**MONTGOMERY COUNTY HISTORIC PRESERVATION COMMISSION**  
**STAFF REPORT**

<b>Address:</b>	15114 Barnesville Road, Boyds	<b>Meeting Date:</b>	12/18/2024
<b>Resource:</b>	Primary (1850-1935) Resource <b>Boys Historic District</b>	<b>Report Date:</b>	12/11/2024
<b>Applicant:</b>	SRK LLC (Jesse Tarr, Agent)	<b>Public Notice:</b>	12/04/2024
<b>Review:</b>	HAWP	<b>Tax Credit:</b>	Partial
<b>Permit No.:</b>	1087171	<b>Staff:</b>	Laura DiPasquale
<b>Proposal:</b>	New ADA access, porch alterations, fenestration alterations and other work

Staff recommends the HPC **approve with one (1) condition** the HAWP application:

**Figure 8: Revised elevation drawings showing the revised porch and ramp railings.**

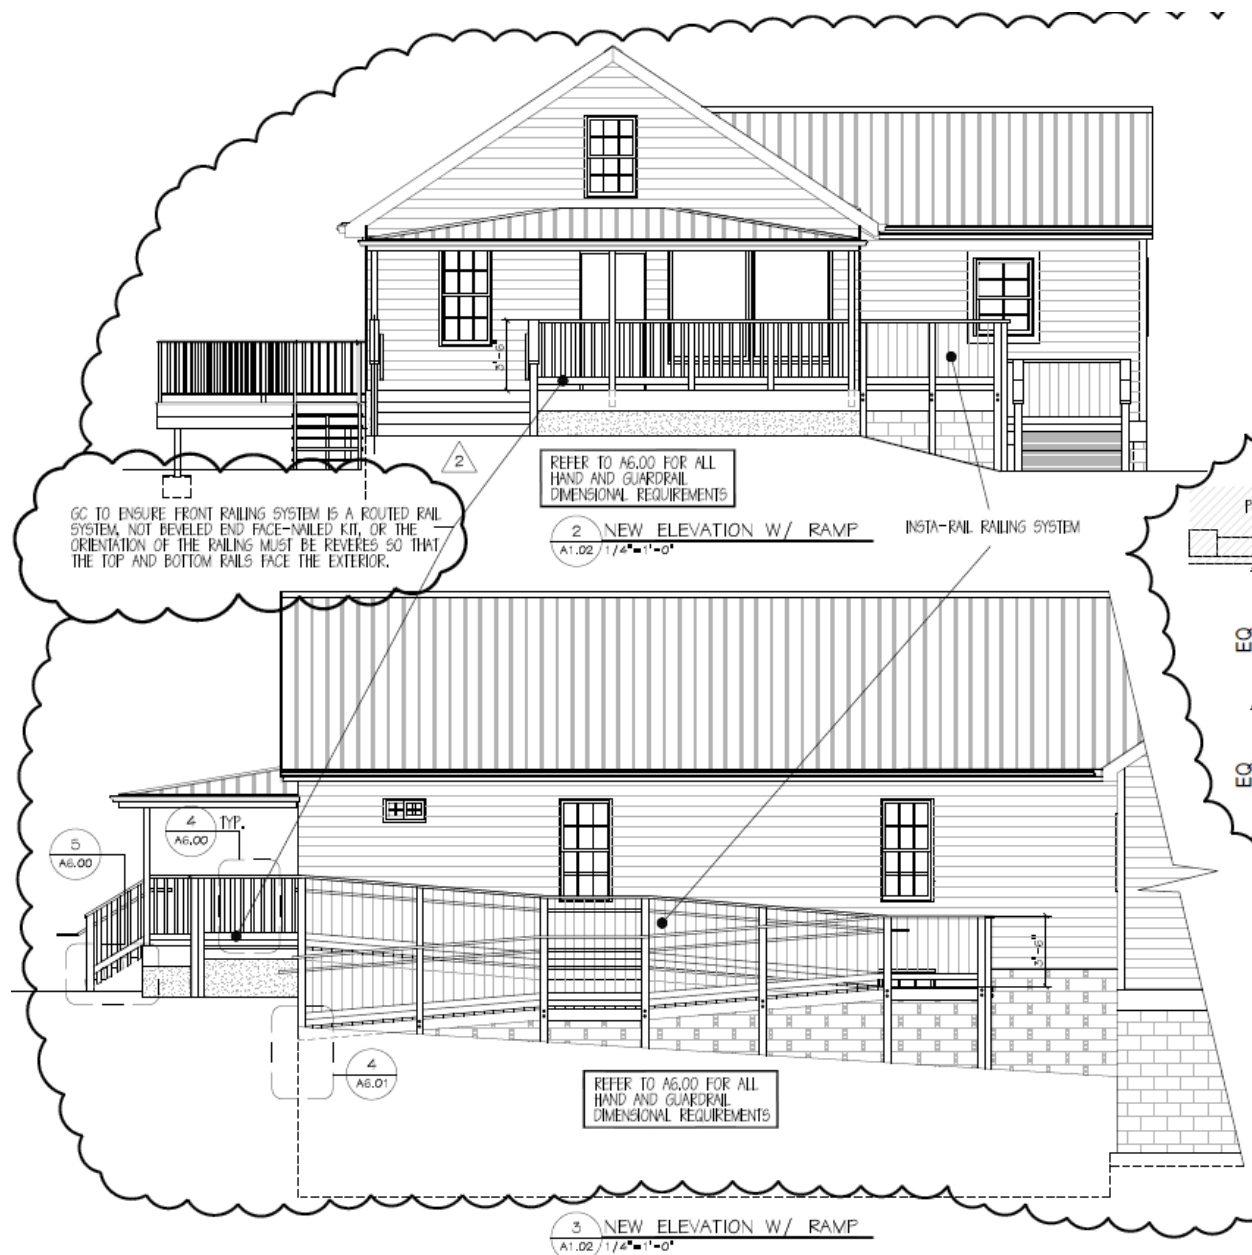
Staff supports the revised ramp railing, finding that it addresses the HPC’s concerns over the conspicuousness of the wood railing system. The Secretary of the Interior’s *Guidelines for Preserving, Rehabilitating, Restoring & Reconstructing Historic Buildings (Guidelines)*, which extrapolates upon the more succinct *Standards*, includes “recommended” and “not recommended” practices as they relate to code-required work. Regarding accessibility, the *Guidelines* recommend “identifying the historic building’s character-defining exterior features, interior spaces, features, and finishes, and features of the site and setting which may be affected by the accessibility code-required work,” “complying with barrier-free access requirements in such a manner that the historic building’s character-defining exterior features...and features of the site and setting are preserved or impacted as little as possible,” and “finding solutions to meet accessibility requirements that minimize the impact of any necessary alteration on the historic building, its site, and setting, such as compatible ramps, paths, and lifts.”<sup>2</sup> Staff finds that the

proposal limits the removal of historic materials and physical impact to the historic building and could be removed in the future without impairing the essential form and integrity of the property, in keeping with *Standard 10*, and that the revised design would not have a negative visual impact on the historic resource, satisfying the *Guidelines*, and Chapter 24A-8(b)(2), and would aid in public utilization of the resource in a manner compatible with the historic resource, satisfying Chapter 24A-8(b)(3).

Figure 9: Elevation drawings from the preliminary consultation review.

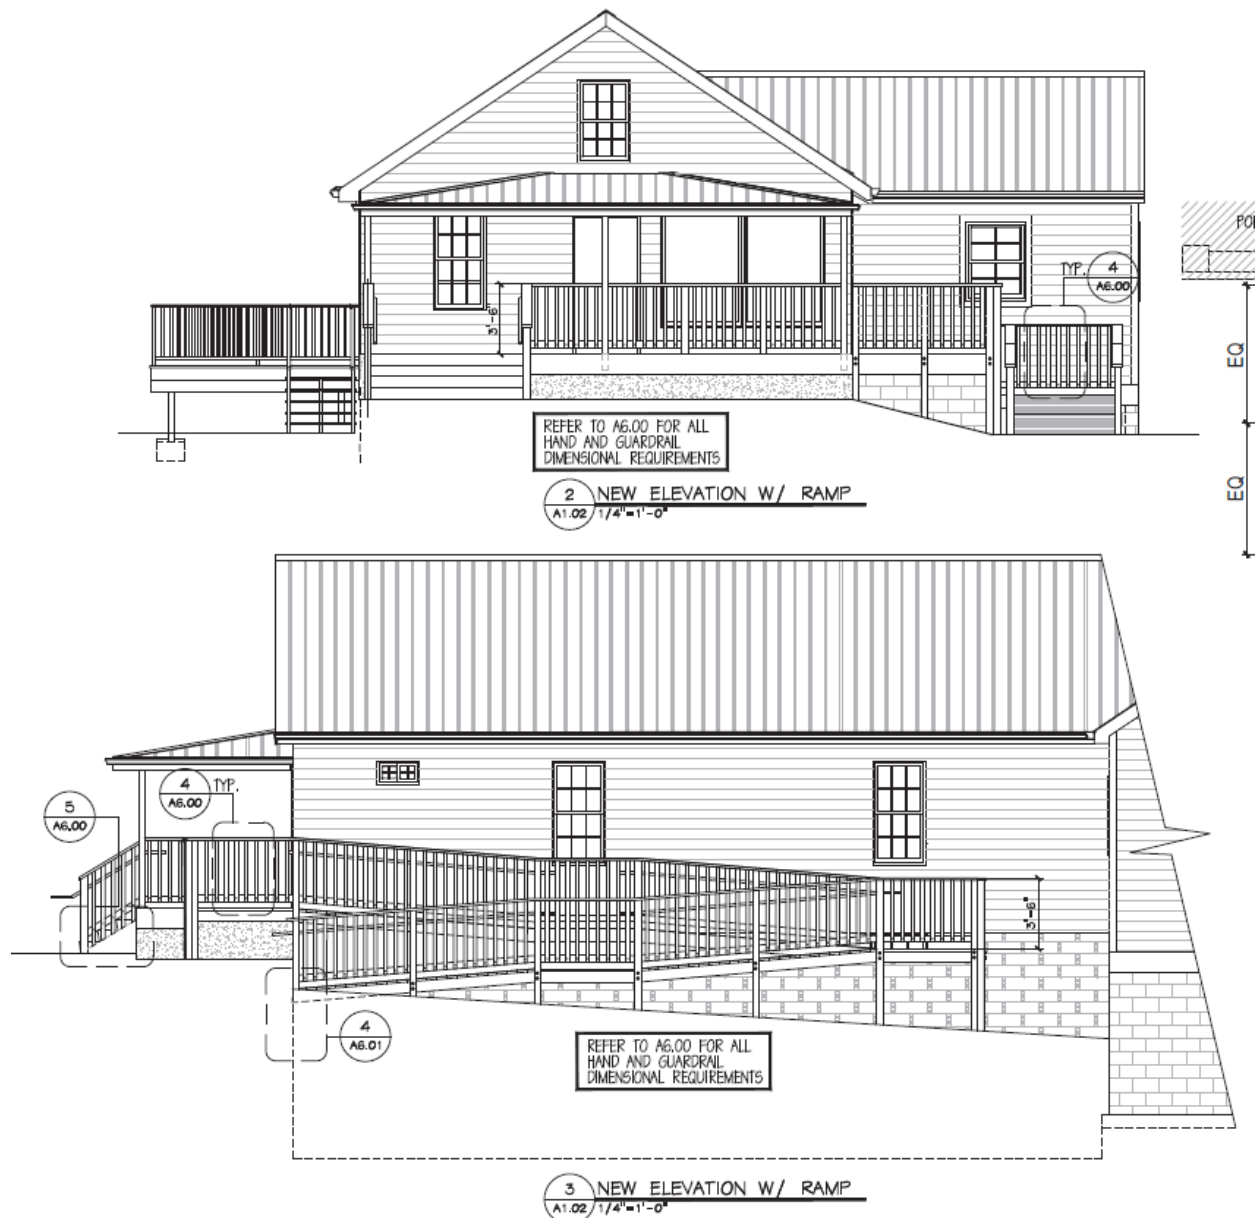
- ADA compliance is necessary for the commercial use of the property, but as presented the proposed switchback ramp appears overly conspicuous, particularly owing to the use of thick pressure treated wood pickets.

- The applicants should consider alternatives to the proposed ramp with vertical pressure treated picket railing, including use of an ADA lift, or alternative railing systems such as thinner wood or metal pickets, or cable railings. The railings should be painted or factory-finished.

Figure 11: Revised proposed front door.

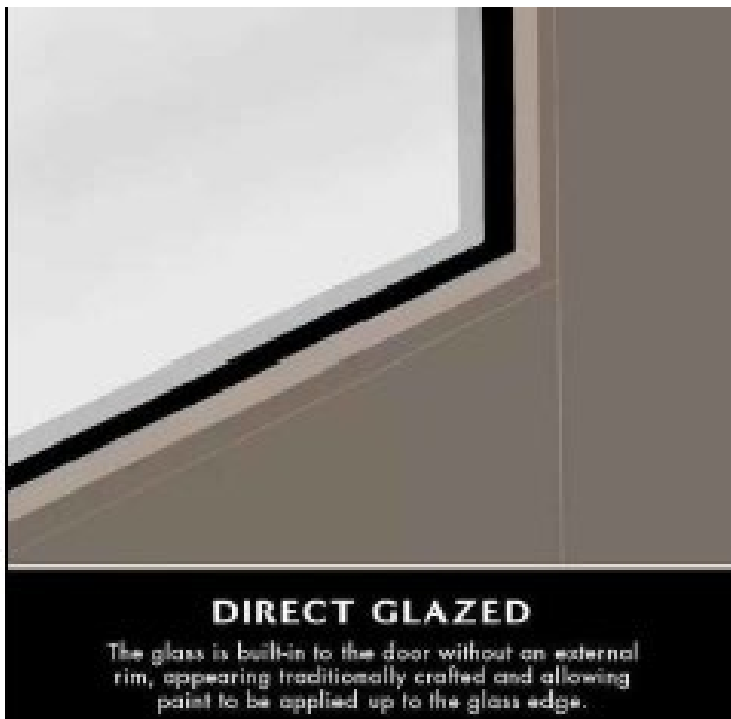
what appears to have been the original door, or an early, compatible door. For the preliminary consultation review, the applicants proposed a similar Craftsman-style door. Commissioners agreed with staff that the proposed Craftsman door was not compatible with the historic commercial resource, and suggested that the applicants approximate the appearance of the earlier door, visible in Google Streetview and in the MCAAtlas photographs of the property (*Figure 10* and *Figure 12*) from the 1980s, which show a half-light wood door with two horizontal panels below.<sup>3</sup> For the current application, the applicants have revised to propose a four-pane, half-light, direct-glazed painted fiberglass door. Staff finds that the proportions and appearance more closely approximate the appearance of the previous door and is compatible with the historic commercial resource, in keeping with Chapter 24A-8(b)(2). Staff further finds that the door replacement would qualify for historic preservation rehabilitation tax credits.

Figure 14: Front elevation showing the location of the picture window to be replaced.

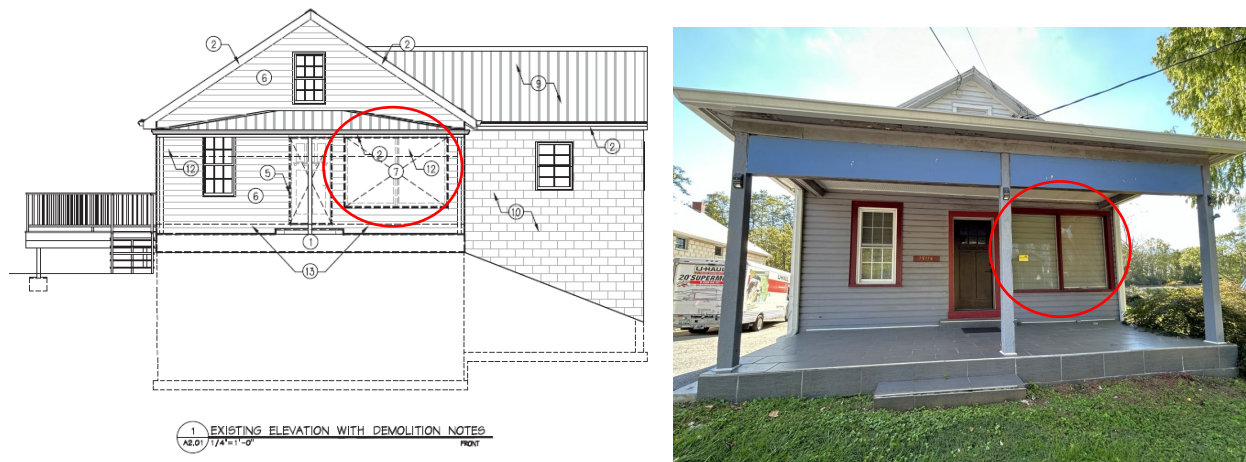
The applicants propose to replace the front double picture window, one side basement window on the east elevation of the historic building, and to install two sets of paired windows in new openings on the west side elevation of the rear addition. Staff notes that the front double picture window is likely an early alteration for commercial purposes, and may have replaced an earlier single window double-hung window opening. Staff have not found any photographs of the property that show the elevation prior to this alteration. The applicants propose to replace the front picture window, which is currently plexiglass, with new glazing in a wood frame. Staff supports this alteration, finding that it will not substantially alter the exterior features of the historic resource and is compatible with the commercial character of the historic property, in keeping with Chapter 24A-8(b)(1) and (2). Staff notes that the front window replacement would qualify for historic preservation rehabilitation tax credits.

1. The new windows must have simulated-divided-lights or no muntins. The pane configuration for the new windows on the addition may be 6-over-6, 2-over-2, or 1-over-1.

**Figure 19: East elevation drawings (existing/demo above, proposed below) showing the addition of Hardie siding over the CMU rear addition.**

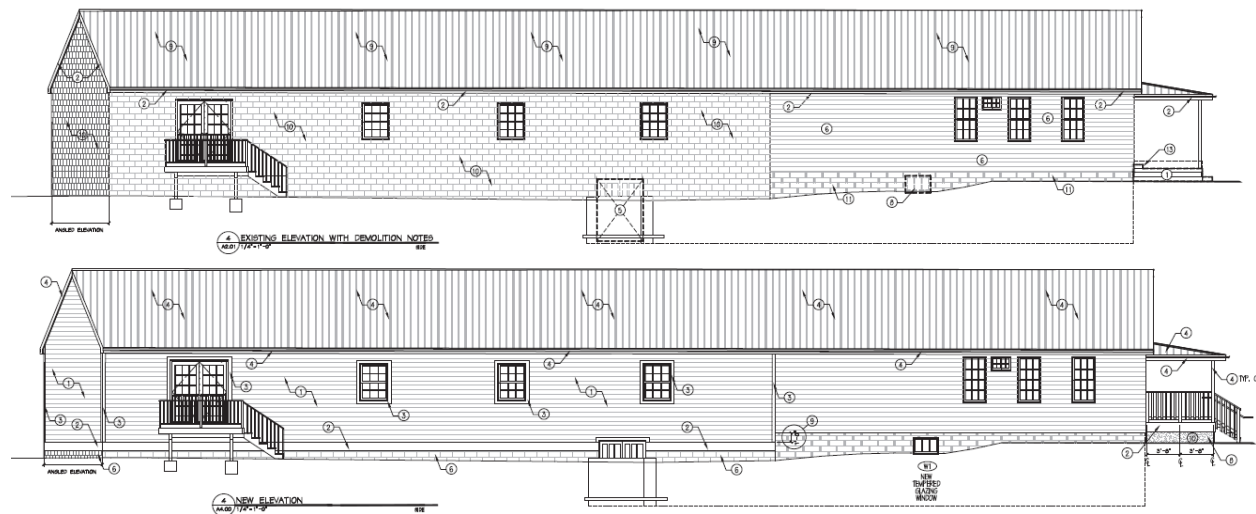
The applicants propose to install new fiber cement Hardie siding over the existing CMU rear addition. New wood trim would be added around the existing and new window openings on the rear addition. Staff does not find that the CMU exterior has any historical significance, and finds that the proposed Hardie siding and wood window trim would be compatible with, but differentiated from, the historic wood clapboard siding, satisfying Chapter 24A-8(b)(2) and *Standard 9*.
